June 29, 1979

Trojan Nuclear Plant  
Docket 50-344  
License NPF-1

I hereby certify that on June 29, 1979, Licensee's letter to the Director of Nuclear Reactor Regulation dated June 29, 1979 and an attachment entitled "Request for Additional Information, Trojan Nuclear Plant, Proposed Control Building Design", have been served upon the persons listed below by depositing copies thereof in the United States mail with proper postage affixed for first class mail.

Figure 3-1

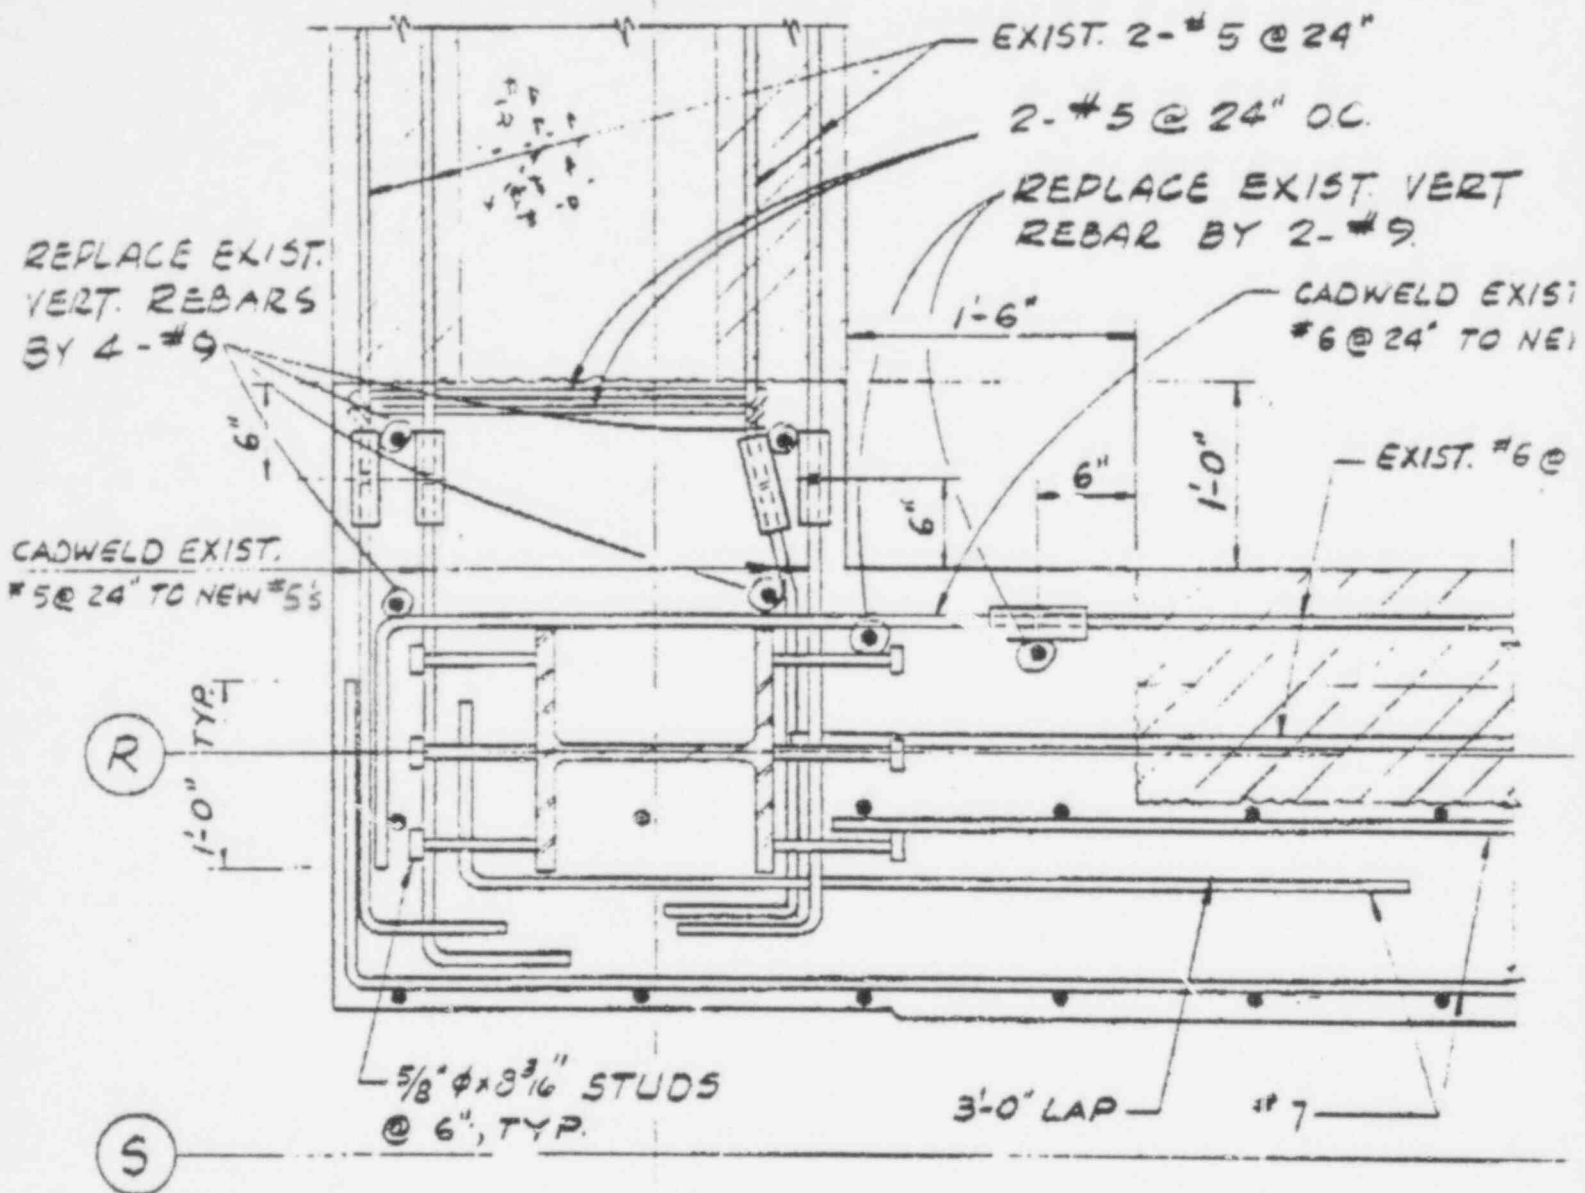
Provide clear, detailed sketches and descriptions of the connection interfaces of the additional walls to the existing structure. Additionally, describe the methods by which the effects of concrete creep and shrinkage (causing tension in the walls and/or a reduction in assumed dead weight) have been factored into the design of these additional walls. Describe and justify in detail the design and the procedures for the connections of the new walls to the existing structure.

Detailed sketches of the connection interfaces between the new walls and the existing structure are attached. The final design may require some minor revisions to the actual sizes and spacings of the rebar and studs. The sketches show representative connection details that will be used. The connection interfaces are discussed below.

Typically, where steel beams occur at a horizontal interface, studs are used to transfer shear forces and vertical rebars are used to transfer tension forces. At horizontal interfaces where steel beams do not exist, vertical rebars make the connection. In some cases friction type A-490 bolts are also used in the connections between the new walls and the existing concrete.

The typical treatment for vertical interfaces is to expose the columns and weld studs on to them. New rebars are spliced with the exposed horizontal existing rebars by cadwelding. Drilled and grouted horizontal rebars are also used to make the connections.

PARTIAL PLAN SHOWING  
AIR SUPPLY PATH TO DIESEL GENERATOR ROOM

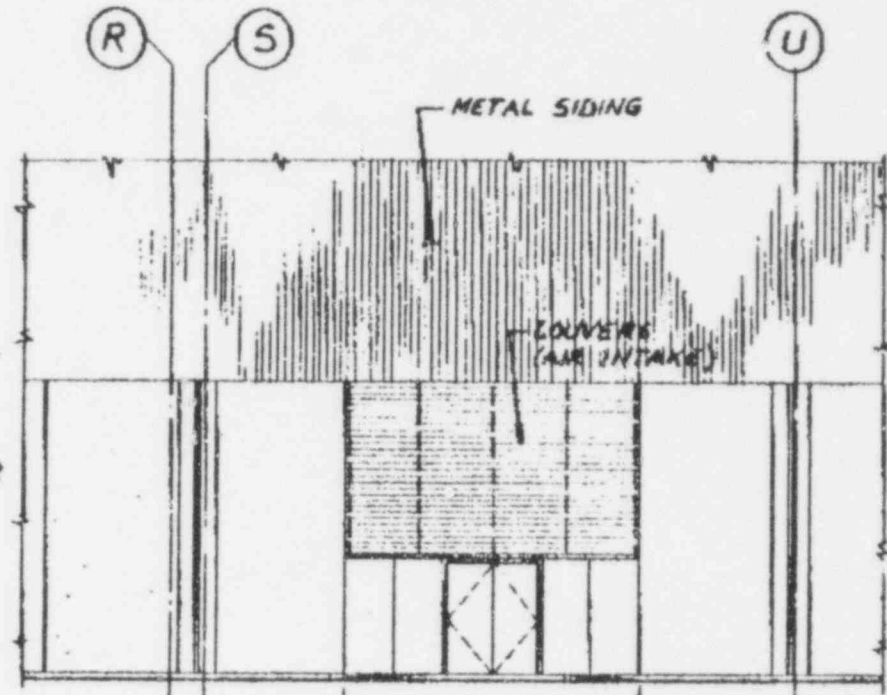
Summarize the loads and load combinations and corresponding acceptance criteria for which the diesel generator air intake will be designed. Include a discussion of how the effects of the Turbine Building, a non-Category I structure has been considered.

The new diesel generator air intake through the north wall of the Turbine Building consists of a louvered opening in the wall. The purpose of the louver is to keep wind, rain, and debris from entering the Turbine Building. The louvers need not be designed for abnormal loads since their collapse would not preclude air supply to the air intake located on the East side of the Diesel Generator Room. In any event, the air intake on the north wall of the Turbine Building has been sized to allow blockage of 50% of the area. The attached figure shows the location of the louver and the air supply path to the Diesel Generator Room.

The fact that the Turbine Building is not a Category I structure has no effect on supplying air to the Diesel Generator Room because it has been designed to resist a Safe Shutdown Earthquake (FSAR Sec. 3.8.1.1.6). The siding and the connections have been analyzed and it has been determined that the siding will not become detached during a Safe Shutdown Earthquake.

FIGURE 41-1 ULTIMATE STRENGTH OF SHEAR WALL SPECIMENS

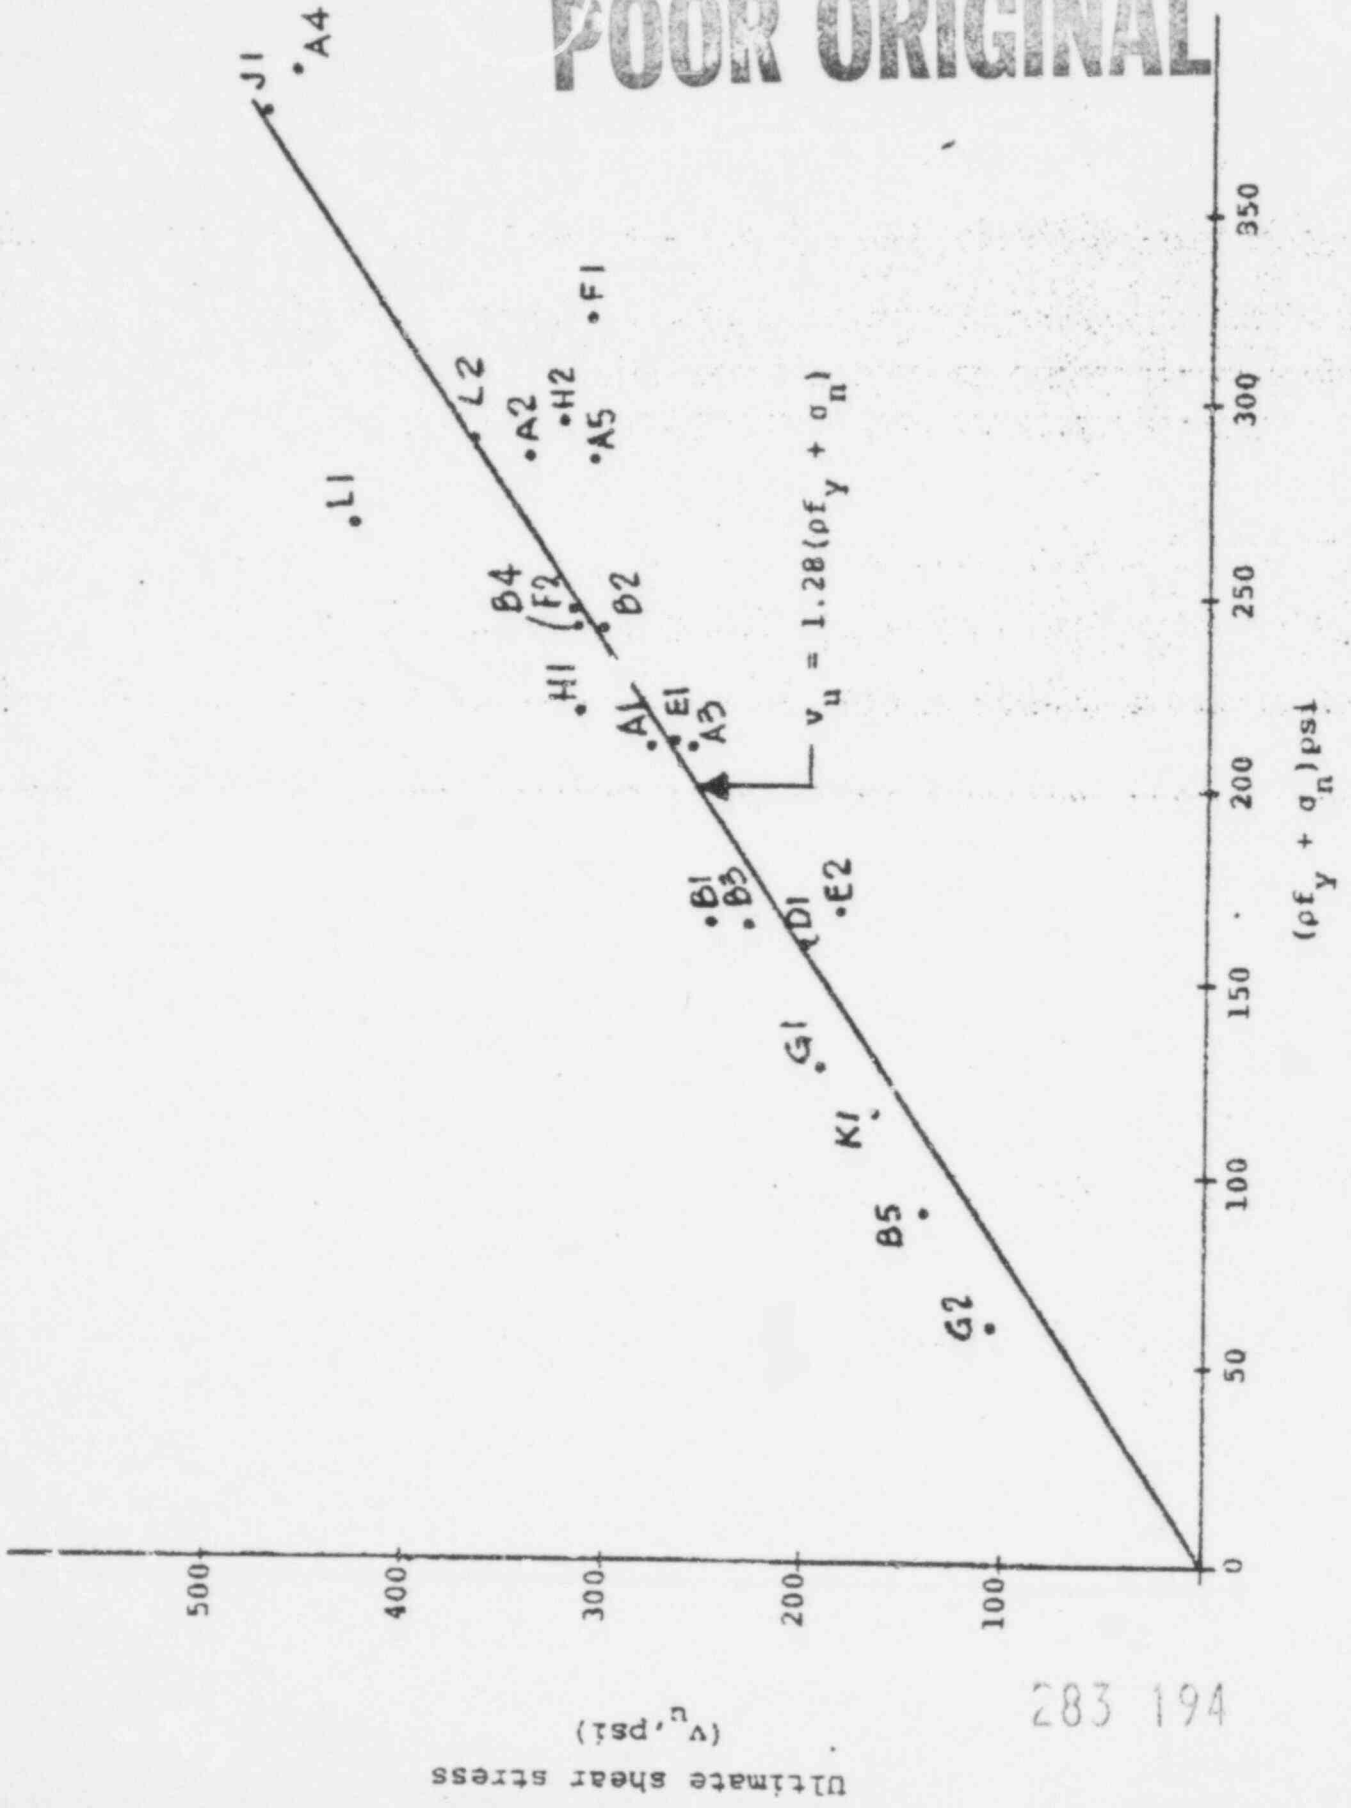
Discuss in detail the error band associated with each of the test results (e.g., stiffnesses, strengths, degradation, etc.). Explain and justify how these were factored into your evaluation of the complex.

The accuracy and consistency in the test results are demonstrated in Figure 41-1 by the small scatter among the ultimate strength of all the 23 specimens. This type of experimental scatter is common among the results of concrete test specimens. Such a scatter can be attributed to various sources as discussed above and other probable sources such as the construction joint at the beam-specimen interface. The consideration of error band associated with the test results is not applicable to the capacity evaluation because the test results were not used directly, as explained in Section 3.4 of PGE-1020.

Figure 49-1 Representative Floor Response Spectra : 0.15g OBE

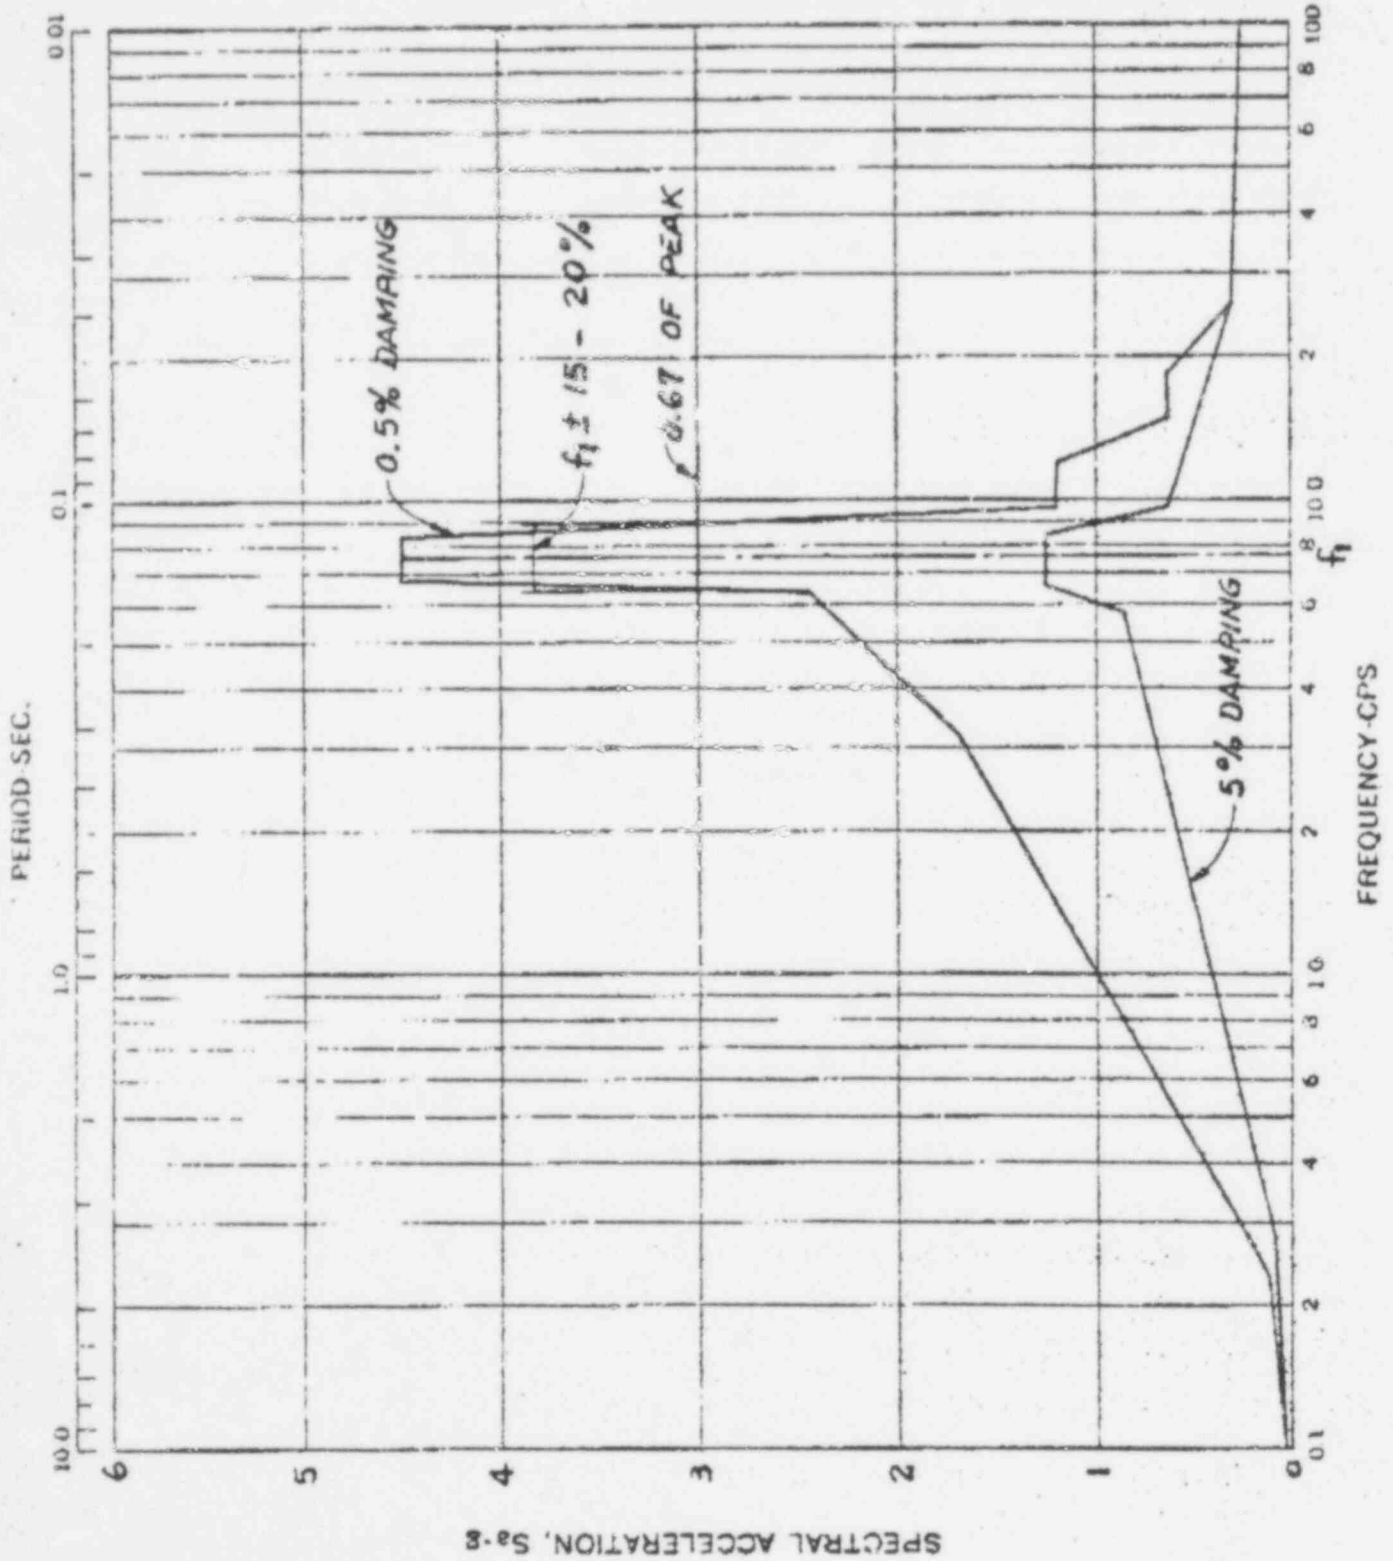
Compare the slopes of the sides of the peaks in floor response spectra for the complex frequency shift vs. stress (therefore, ground acceleration) level as derived from the test data results to verify that the floor response spectra are conservative for all earthquake levels for both the OBE and the SSE spectra. Justify any non-conservative deviations.

of the peaks increases with decreasing acceleration. As shown in Figure 49-1, the width of the peaks of the response spectra for an 0.15g OBE varies between 15 and 20 percent at 0.67 of the peak ordinate. This will allow the frequency shift of 5 to 7 percent, plus approximately 10 percent curve broadening, with the resulting spectra for an 0.10g earthquake still being within the 0.15g OBE response spectra. As the earthquake level increases from 0.10g to 0.15g, the stiffness reduction factors decrease gradually which will result in a gradual transition to the 0.15g response spectra.
